Title - Sujet CCGS Terry Fox VLE	
Solicitation No. - N° de l'invitation F7049-200041/B	Amendment No. - N° modif. 020
Client Reference No. - N° de référence du client F7049-200041	Date 2022-02-17
GETS Reference No. - N° de référence de SEAG PW-\$\$\$MD-043-28394	
File No. - N° de dossier 043md.F7049-200041	CCC No./N° CCC - FMS No./N° VME
Solicitation Closes - L'invitation prend fin at - à 02:00 PM Eastern Daylight Saving Time EDT on - le 2022-05-17 Heure Avancée de l'Est HAE	
F.O.B. - F.A.B. Plant-Usine: <input type="checkbox"/> Destination: <input type="checkbox"/> Other-Autre: <input type="checkbox"/>	
Address Enquiries to: - Adresser toutes questions à: Pandini, Madeleine	Buyer Id - Id de l'acheteur 043md
Telephone No. - N° de téléphone (873) 353-9119 ()	FAX No. - N° de FAX () -
Destination - of Goods, Services, and Construction: Destination - des biens, services et construction:

Solicitation Amendment # 020

3. To update Annex A - Statement of Work (SOW), Part B SOW item 11.14.

Under section 11.14 Internal Steel Repairs:

b) Figure 2: Port Supply Trunking - Aft Side

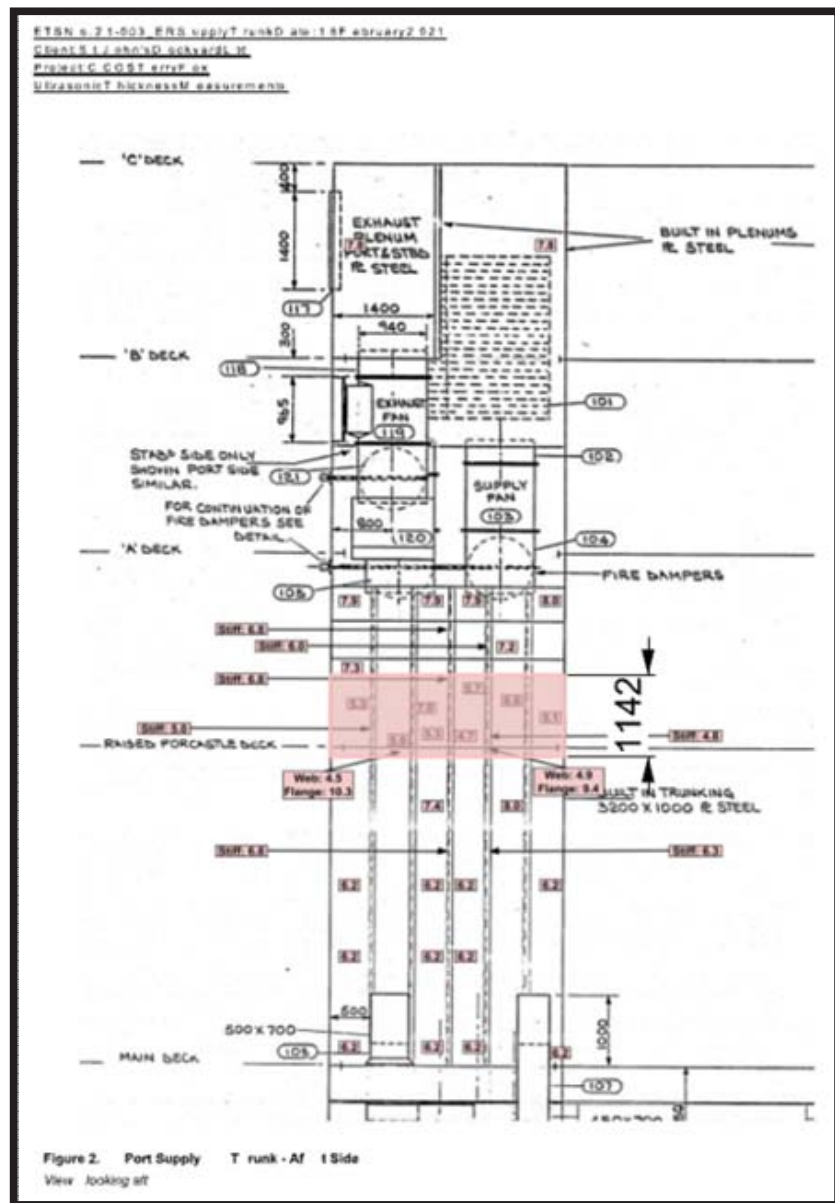
- Contractor must crop out and replace, with a new 6.5 mm steel section of the trunking plating approximately 3200mm by 1142mm in size, in the location defined by the shaded area.
- The new insert must have stiffeners installed per the removed plating and connected (welded) to the existing stiffeners.

- The existing horizontal web plating must be cropped out and replaced with a new section of 8 mm steel plate with approximate dimension(s) of 3200 mm by 300mm.
- The existing vertical flange plating must be cropped out and replaced with a new section of 12 mm steel plate with approximate dimension(s) of 3200 mm by 457mm.

c) Figure 3: Port Supply Trunking – Inboard Side

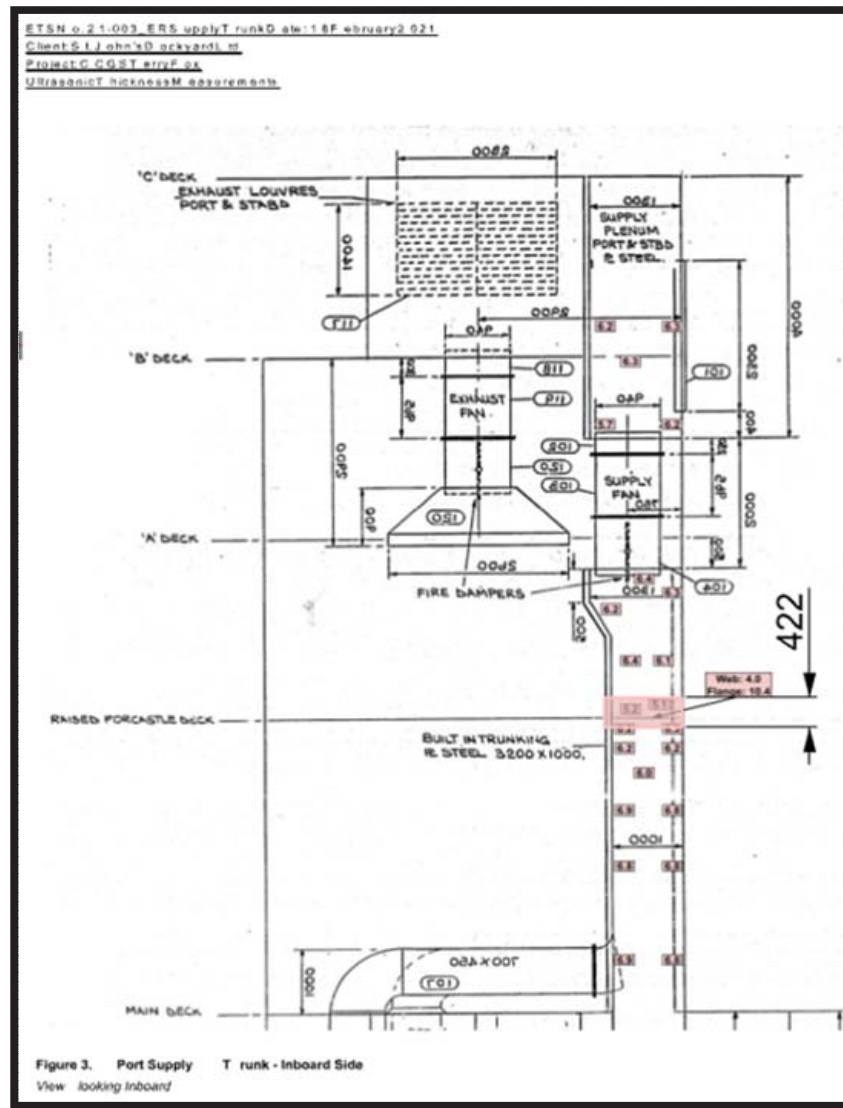
- Contractor must crop out and replace, with a new 6.5 mm steel section of the trunking plating approximately 1000mm by 422 mm in size, in the location defined by the shaded area.

- The existing horizontal web plating, located at the raised forecastle deck level, must be cropped out and replaced with a new section of 8 mm steel plate with approximate dimension(s) of 1000 mm by 457mm.
- The existing vertical flange plating must be cropped out and replaced with a new section of 12 mm steel plate with approximate dimension(s) of 1000 mm by 300mm.

d) Figure 4: Port Supply Trunking – Outboard Side

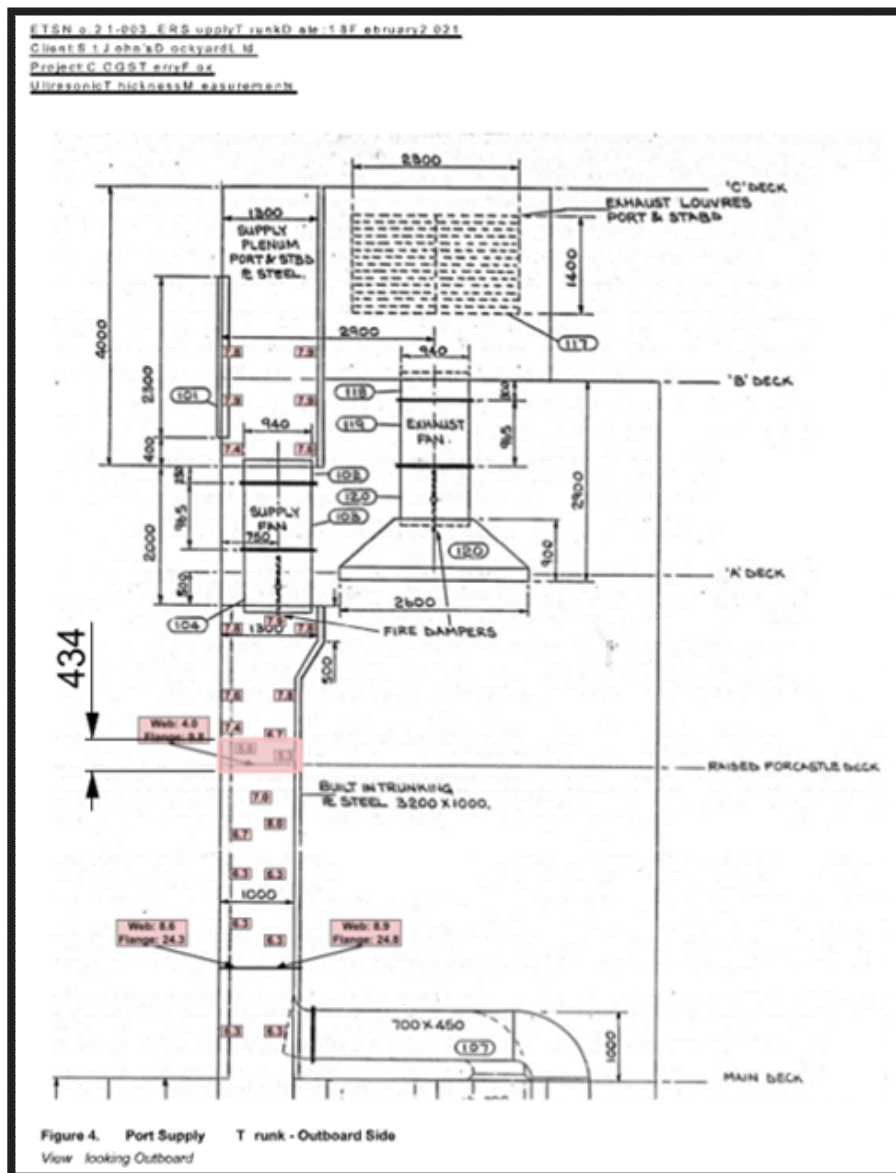
- Contractor must crop out and replace, with a new 6.5 mm steel section of the trunking plating approximately 1000mm by 434mm in size, in the location defined by the shaded area.

- The existing horizontal web plating must be cropped out and replaced with a new section of 8 mm steel plate with approximate dimension(s) of 1000 mm by 457mm

e) Figure 6: Stbd Supply Trunking Forward Side

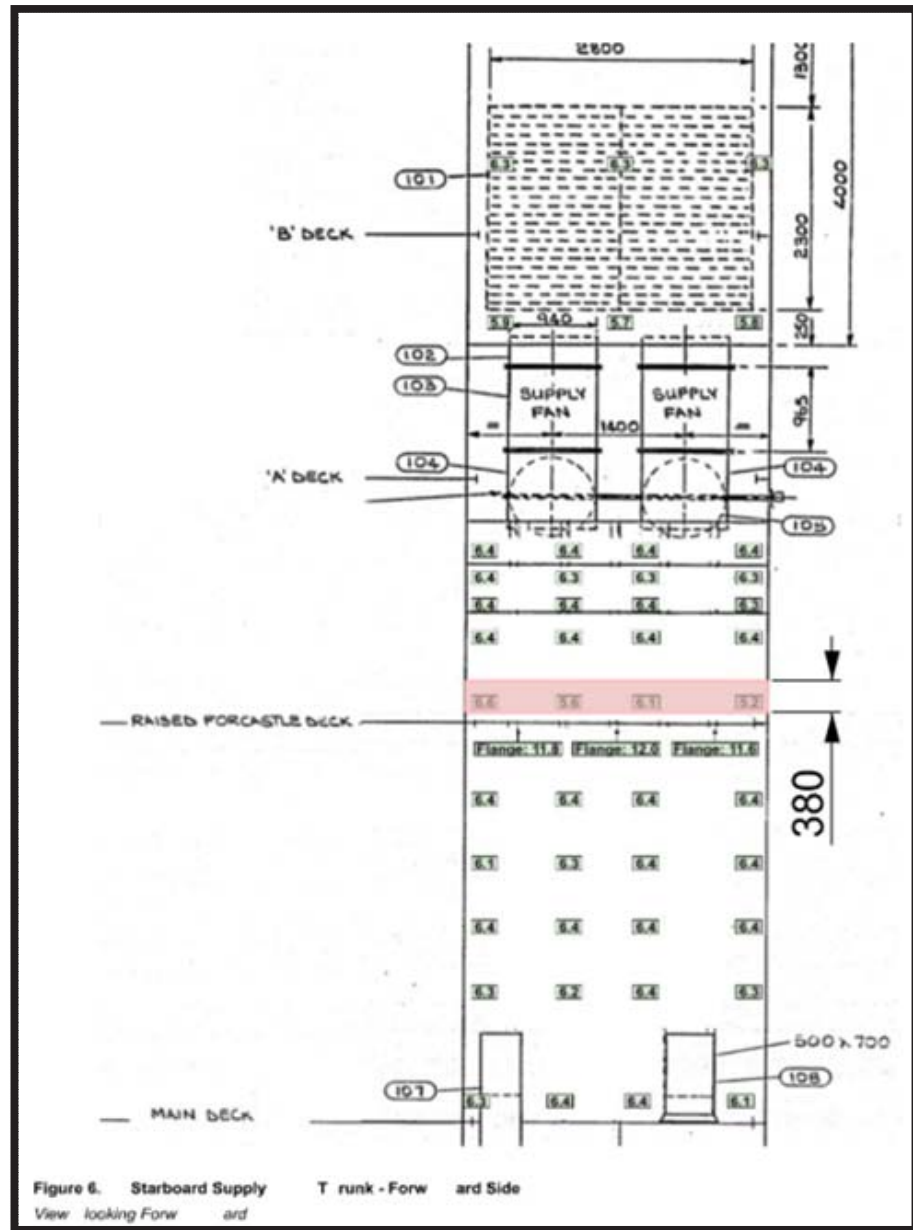
- Contractor must crop out and replace, with a new 6.5 mm steel section of the trunking plating approximately 3200mm by 380mm in size, in the location defined by the shaded area.

f) Figure 7: Stbd Supply Trunking -Aft Side

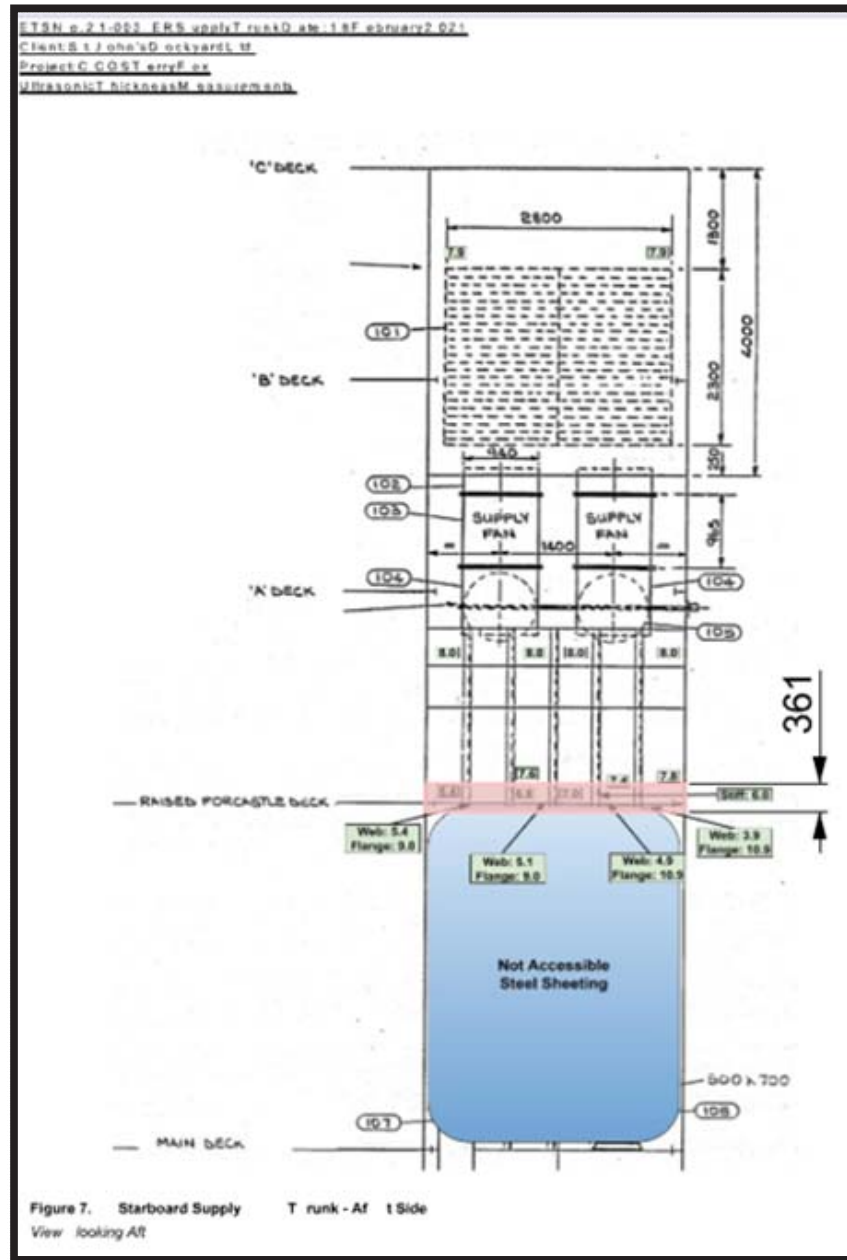
- Contractor must crop out and replace, with a new 6.5 mm steel section of the trunking plating approximately 3200mm by 361mm in size, in the location defined by the shaded area.
- The existing horizontal web plating, located at the raised forecastle deck level, must be cropped out and replaced with a new section of 8 mm steel plate with approximate dimension(s) of 3200 mm by 457mm.

- The existing vertical flange plating must be cropped out and replaced with a new section of 12 mm steel with approximate dimension(s) of 3200 mm by 300mm.

g) Figure 8: Stbd Supply Trunking Inboard Side

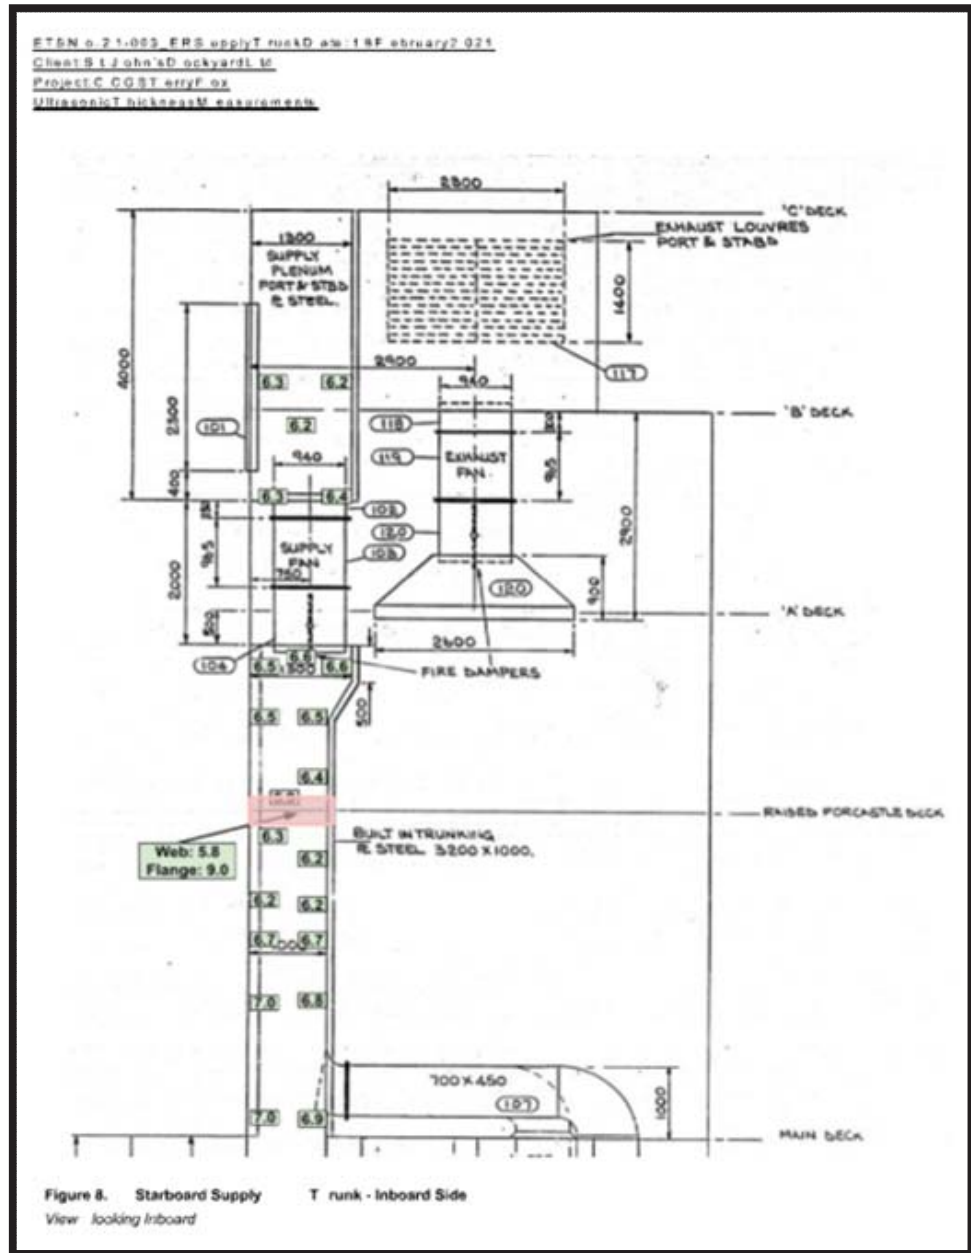
- The existing horizontal web plating, located at the raised foc'sle deck level, must be cropped out and replaced with a new section of 8 mm steel plate with approximate dimension(s) of 1000 mm by 457mm.

- The existing vertical flange plating must be cropped out and replaced with a new section of 12 mm steel plate with approximate dimension(s) of 1000 mm by 422mm.

h) Figure 9: Stbd Supply Trunking Outboard Side

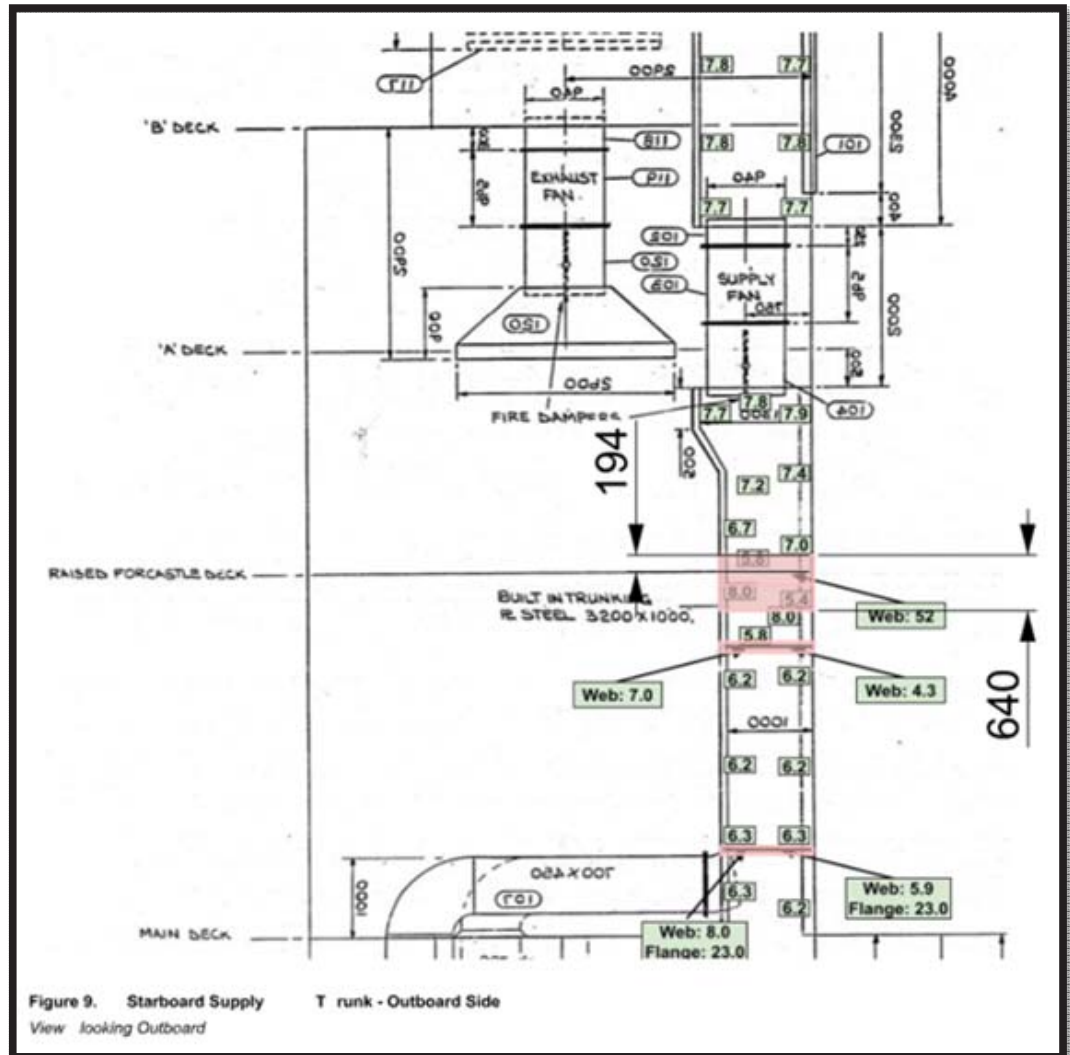
- Contractor must crop out and replace, with a new 6.5 mm steel section of the trunking plating approximately 1000mm by 422 mm in size, in the location defined by the shaded area.
- The existing horizontal web plating must be cropped out and replaced with a new section of 8 mm steel plate with approximate dimension(s) of 1000 mm by 422mm
- The existing horizontal web plating, located approximately one (1) meter below the raise forecastle deck must be cropped out and replaced with a new section of 10 mm steel plate with approximate dimension(s) of 1000 mm by 457mm.

- The existing horizontal web plating, located approximately two (2) meters above the Main Deck level, must be cropped out and replaced with a new section of 10 mm steel plate with approximate dimension(s) of 1000 mm by 457mm.
